Hope Creek Generating Station
Renewed Facility Operating License No. NPF-57
NRC Docket No. 50-354

Subject: Hope Creek Generating Station Compliance with NRC Order to Modify Licenses with Regard to Reliable Spent Fuel Pool Instrumentation (Order EA-12-051) and Responses to Requests for Additional Information

**Hope Creek Generating Station (HCGS)
Response to Interim Staff Evaluation and Request for Additional Information
Reliable Spent Fuel Pool Instrumentation**

Figure	Description
1a	Section View – West Probe
1b	Section View – Northeast Probe
2	Mounting Plate Detail
3	Plan View – Northeast Probe
4	Plan View – West Probe

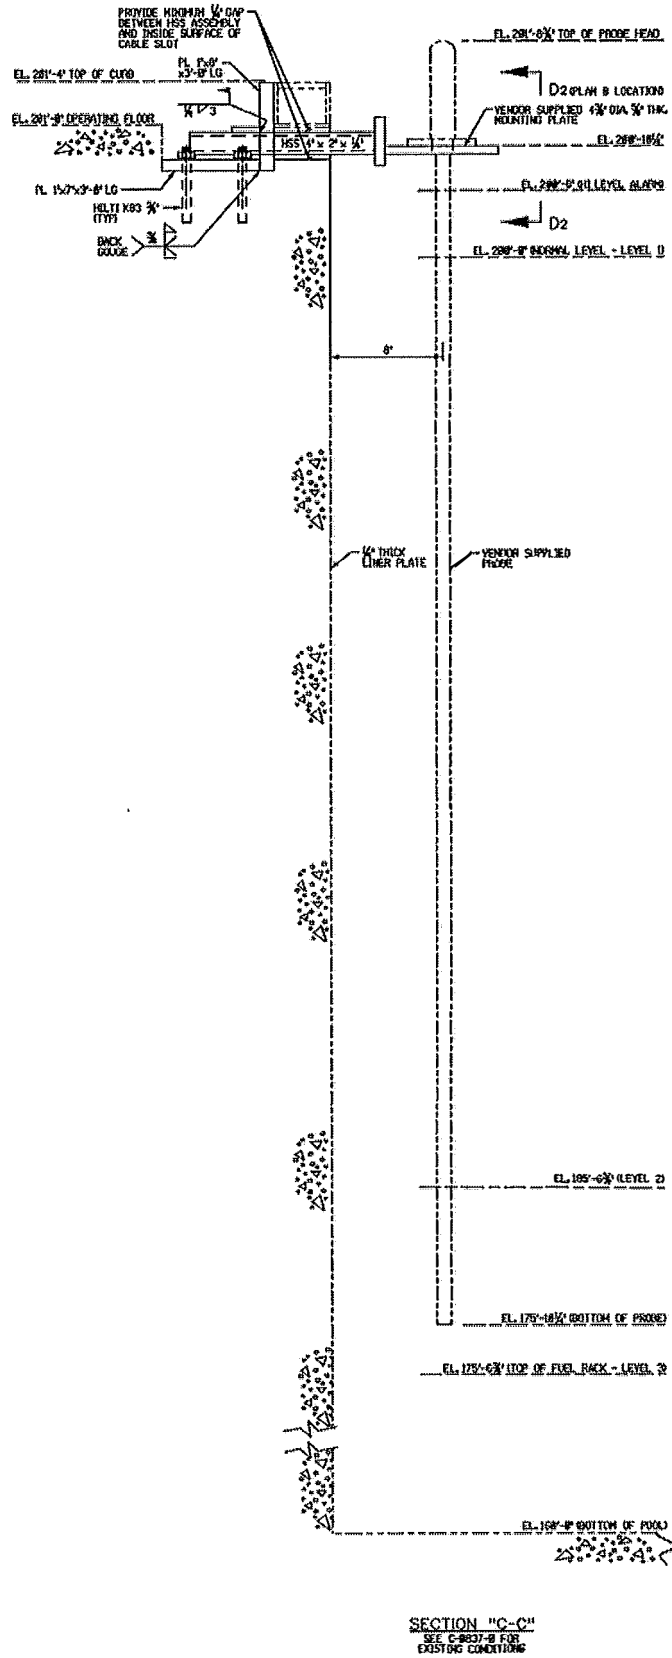
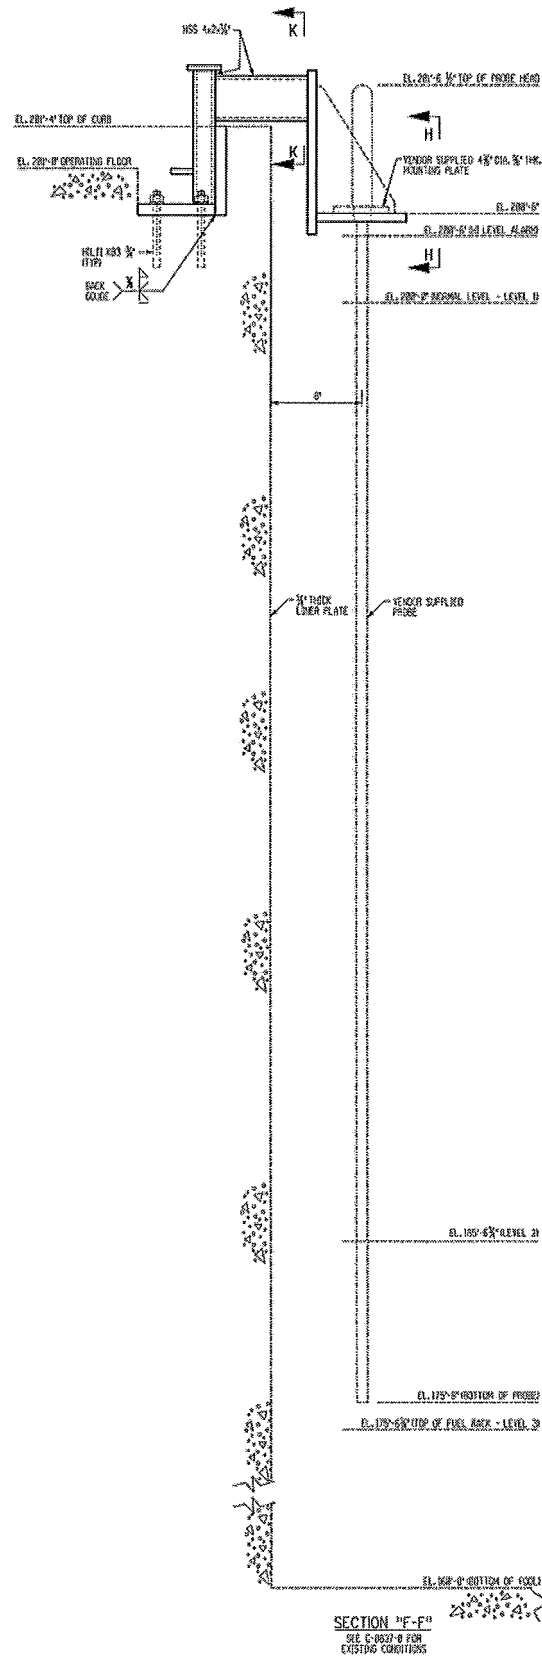
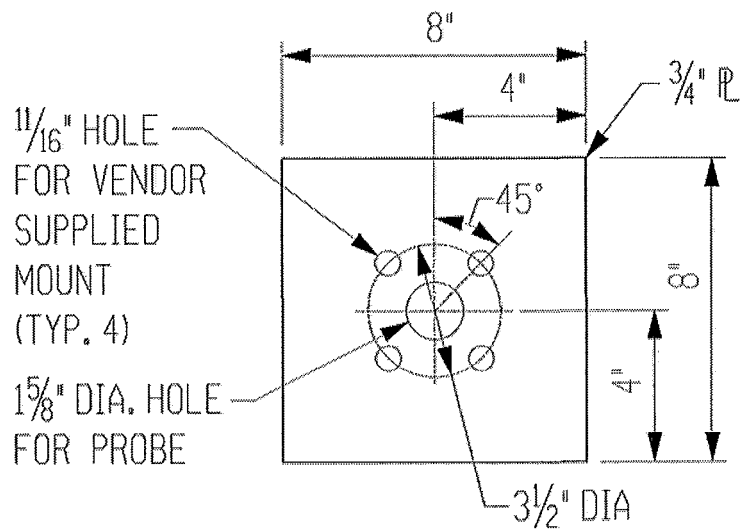
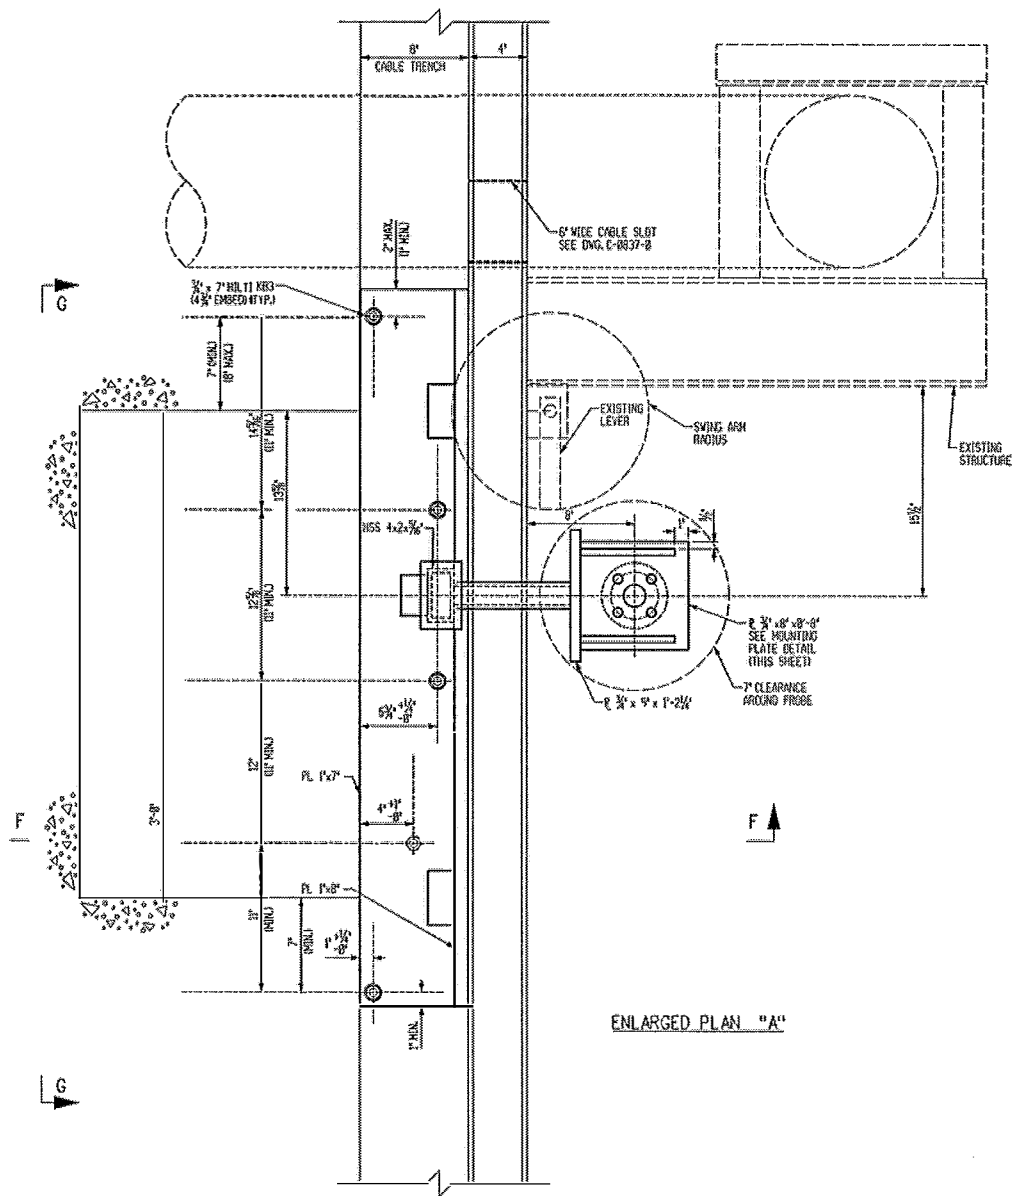
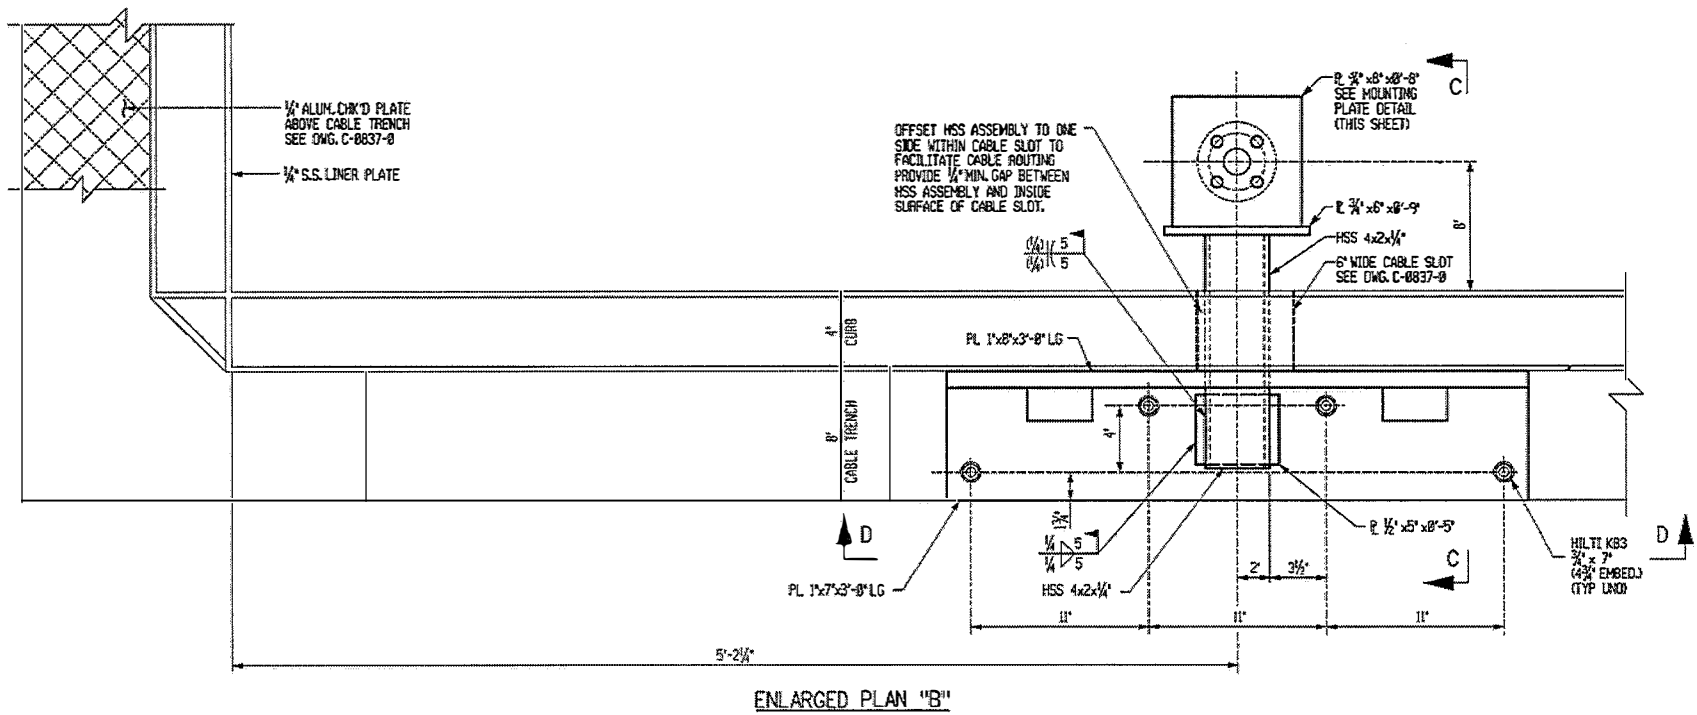
- a) The design criteria that will be used to estimate the total loading on the mounting device(s), including static weight loads and dynamic loads. Describe the methodology that will be used to estimate the total loading, inclusive of design basis maximum seismic loads and the hydrodynamic loads that could result from pool sloshing or other effects that could accompany such seismic forces.
- b) Indicate in a schematic, the portions of the level sensor that will serve as points of attachment for mechanical/mounting or electrical connections.
- c) A description of the manner by which the mechanical connections will attach the level instrument to permanent SFP structures so as to support the level sensor assembly.

- b) The support structures are anchored to the concrete curb around the SFP above the refueling deck as shown in the following figures:

- c) The level sensor is designed to be attached near its upper end to the support structure as shown in Figures 1a, 1b, 2, 3, and 4.
